CM CLARIFICATION #004

PROJECT: CNE Tahlequah Casino

ADDENDUM # 001

Tahlequah Casino Addendum #01 summary

SHEET NUMBER:
PU1.1
PLUMBING ENLARGED
UNDERSLAB PLAN -
GAMING

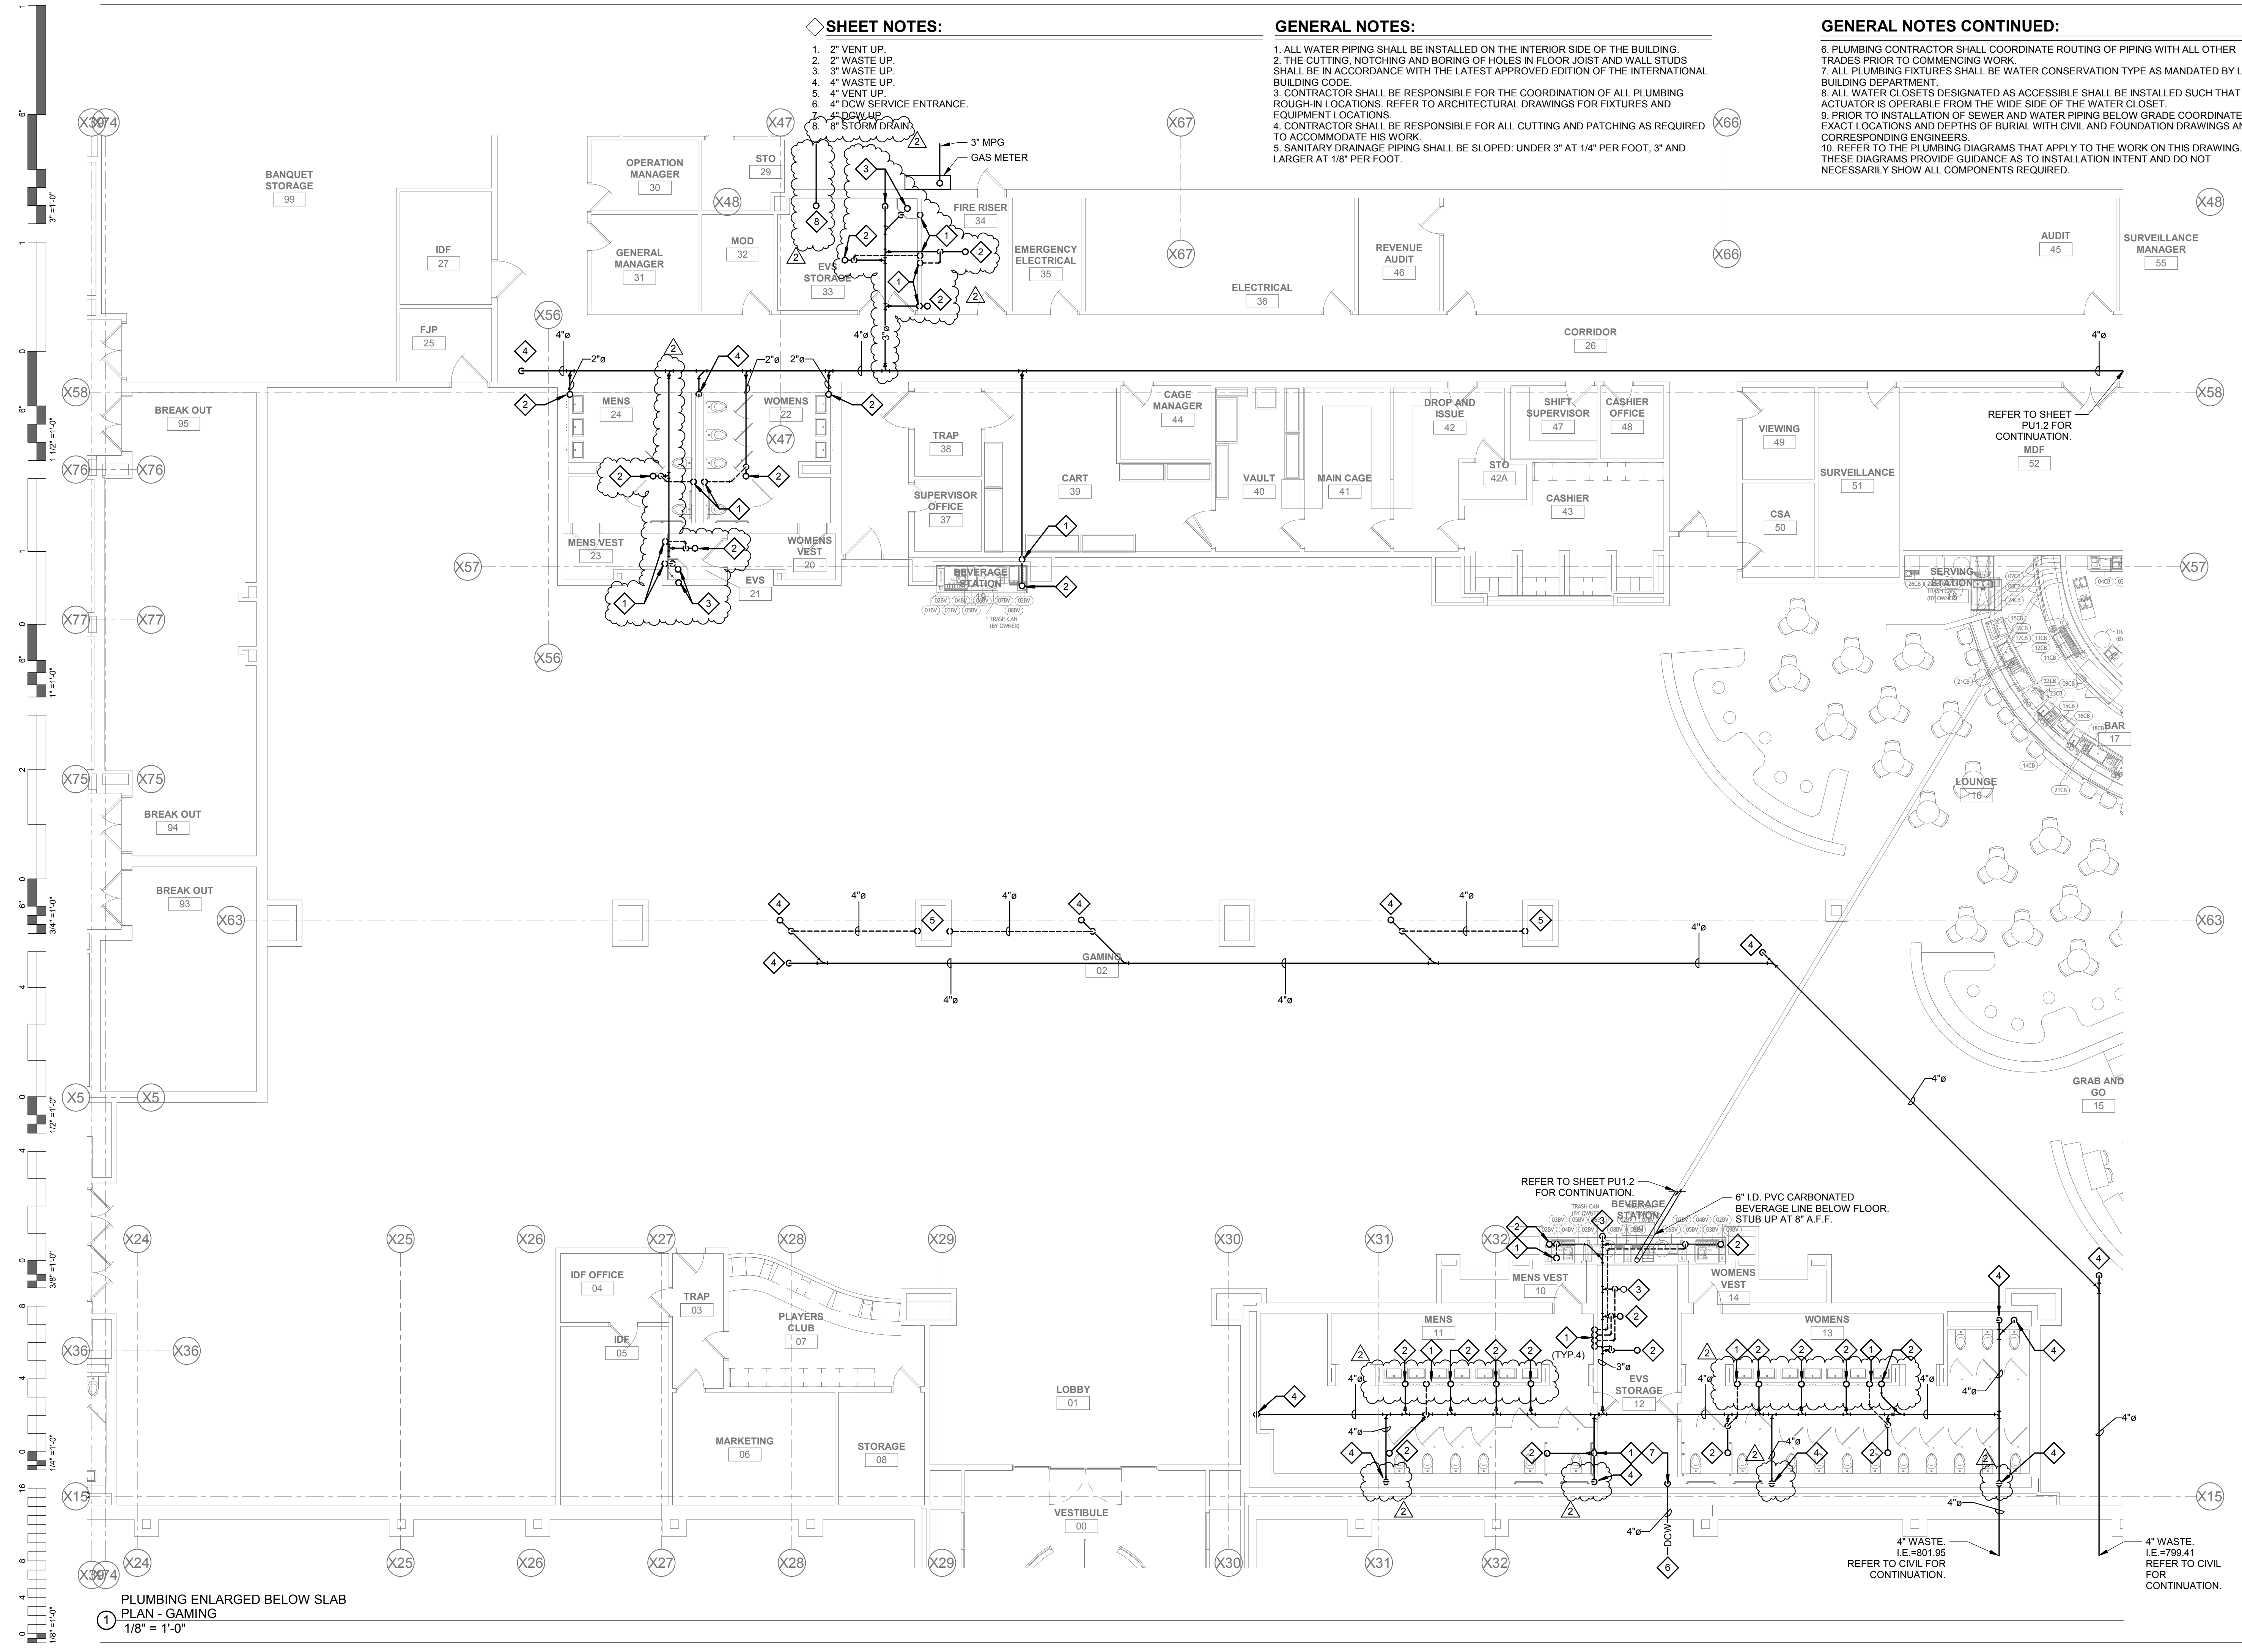
<u>Sheets</u>	<u>Description</u>
PU1.1	Added (1) 8" Storm drain penetration / floor drain / mop sink to EVS Storage 33. Added floor drain / mop sink EVS 21. Moved waste and vent lines into architectural wall shift in Mens 11 & Womens 13. Added floor drain / sink to Fire Riser 34.
PU1.2	Added carbonated beverage/liquor lines in Bar 17. Extend waste/vent lines to hand sinks in Kitchen 75 & 79. Added mop sink & floor drain to EVS 79B and mop sink to 79A. Relocated vent lines to consolidated column in Bar 85. Added carbonated beverage lines to Bar 85.
PU1.3	Added (2) 8" storm drain penetrations.
PU1.4	Extend waste/vent lines to hand sinks in Banquet Food Preparation 98. Added (3) 8" storm drain penetrations.
PU1.5	Added (2) 4" storm drain penetrations. Added mop sink and floor drain to EVS 91 & 93.
